Subject: Limerick Generating Station
Response to Procedures and Systems Review
Branch (PSRB) Questions

Selection of LGS Containment Vent Pressure

LGS Containment Venting Provisions

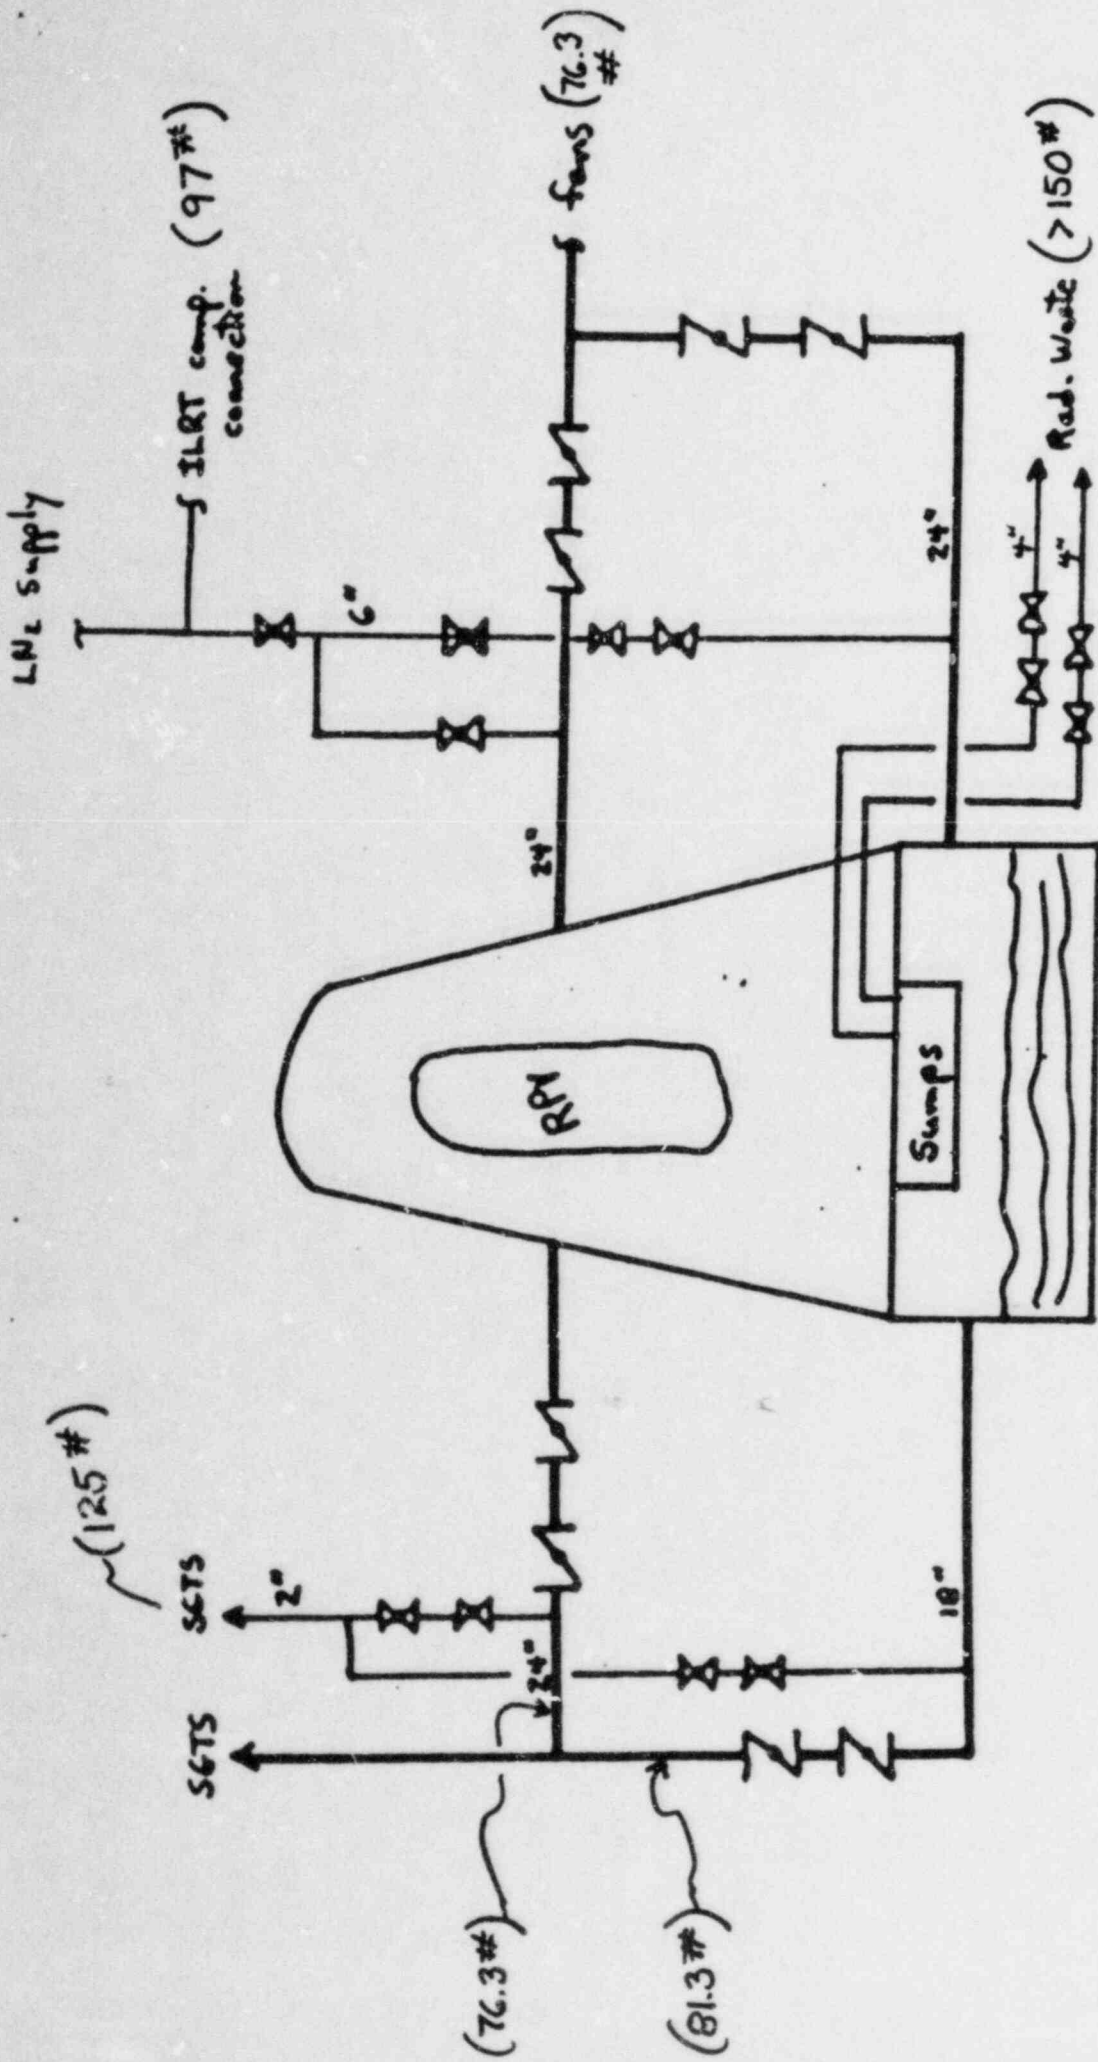
- The isolation valves in the above vent paths have been determined to be operable (i.e. - for opening and closure) for differential pressures ranging from 76 psid to over 150 psid. The evaluation of valve operability has included consideration of all relevant loads, including flow induced dynamic effects. Valve performance characteristics have been derived from analysis and test results. Those valves with the lowest differential pressure capability, the 18" and 24" valves, are all oriented such that containment pressure resists valve opening, or assists valve closure. The operability of these valves is limited by the actuator torque available for opening. Thus, valve reclosure would be assisted by containment pressurization. Initiation of the venting sequence at the selected pressure limit will assure that venting is not begun before conditions warrant and that the vent valves will be used before pressures challenging their operability are reached. The differential pressure rating and size of each vent path is indicated on the attached sketch.
